LETTER OF SUBMITTAL
KFM Skyway Project # 04-012024

SUBMITTAL No: KFM-SUB-006970 **Rev:** 00

Subject: Kie-Con NCR for fender module FP-1A-5 #16 rebar stick out

Non Conformance Report

(TYPE 1A) FP-1A REINFORCEMENT

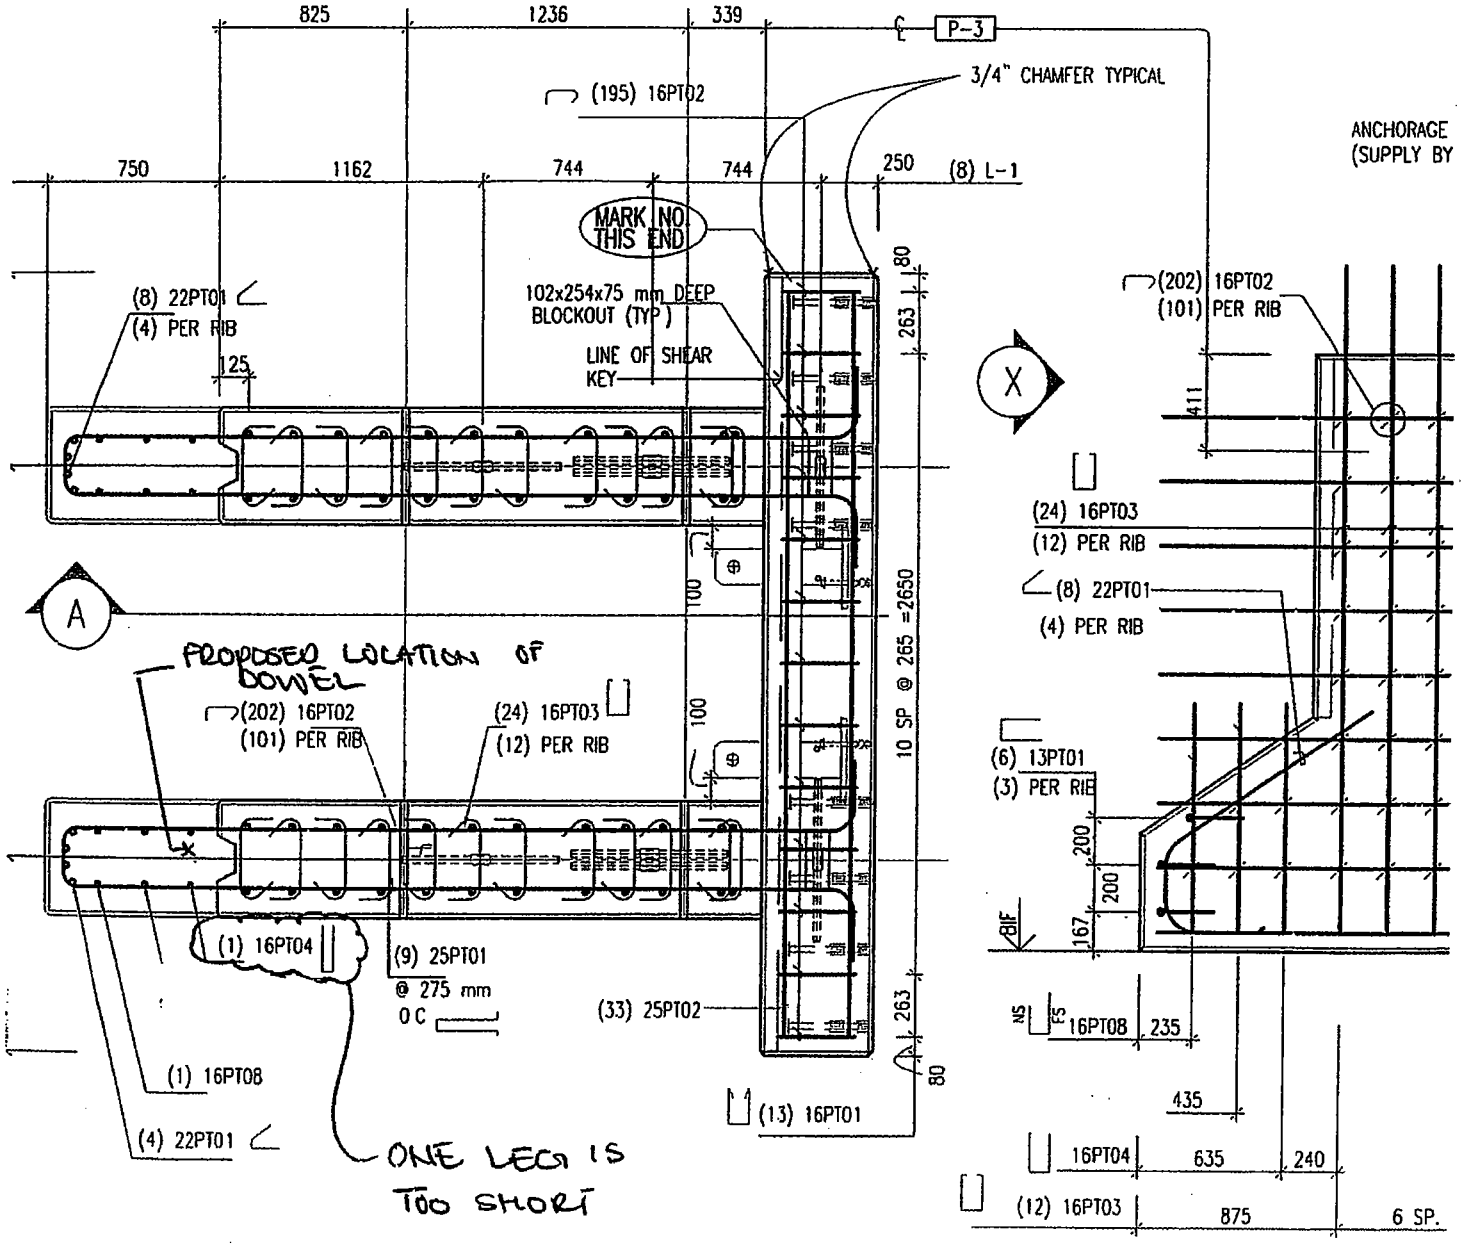
1 LEG OF IGPT04 IS ALMOST FLUSH WITH CONCRETE SURFACE LEAVING NO ROOM FOR COUPLER @ THE JOB SITE.
(SEE ATTACHE DRAWING)

One leg of 16PT04 is almost flush with the concrete surface leaving no room for coupler at the job site (See attached Drawings).

1. A hole will be drilled adjacent to the existing bar and toward the center line of fender Rib with a roto-hammer. The hole diameter will be 19 mm.
2. The hole will be blown clean with compressed air and wire brush.
3. Simpson's Epoxy-Tie SET adhesive will be used to install the new dowel. The dowel will be installed per Simpson Strong-Tie's instruction for Epoxy-Tie Set.
4. #16 dowel will have a minimum of 140 mm embedment.

We approve of the recommendation made by KFM in the Non-Conformance Report, which reflects the recommendation made by the manufacturer (Simpson anchors) for using this product called Epoxy-Tie Set Adhesive.

Please be advised, however, that the PCQCP report for Fender Module FP-1A-5 (KFM-Sub-6123) was approved on March 6, 2006 with the STL 9689. Thus, please revise and re-submit KFM-Sub-6970 to include this NCR.
